VOLUME	GROUP Engine
2	NUMBER 004

MODEL Sedona DATE

Technical Service Bulletin

Cooling Fan Noise

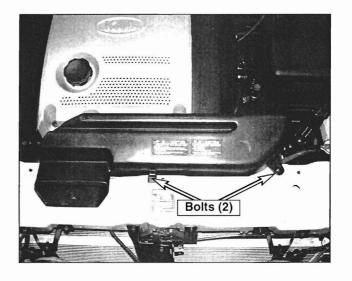
1. Remove two bolts and loosen clamp on air intake duct, remove duct.

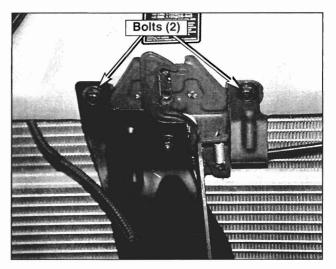
2. Remove two bolts securing hood latch to upper radiator support.

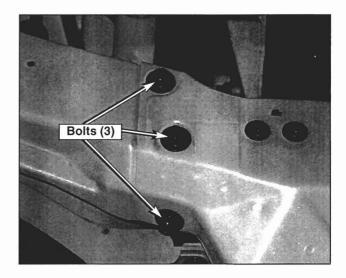
3. Remove three bolts at each end of upper radiator support.

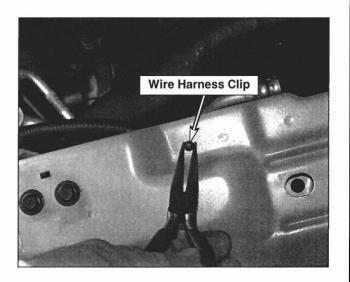
4. Release four wiring harness clips from upper radiator support.

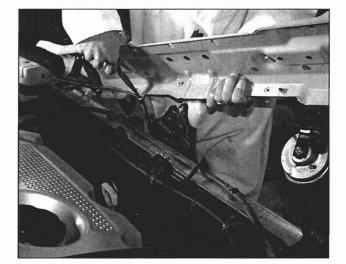
- 5. Tilt upper radiator support forward, and release clip on hood release cable. Remove upper radiator support.
- 6. Remove cooling fan attaching bolts (3).
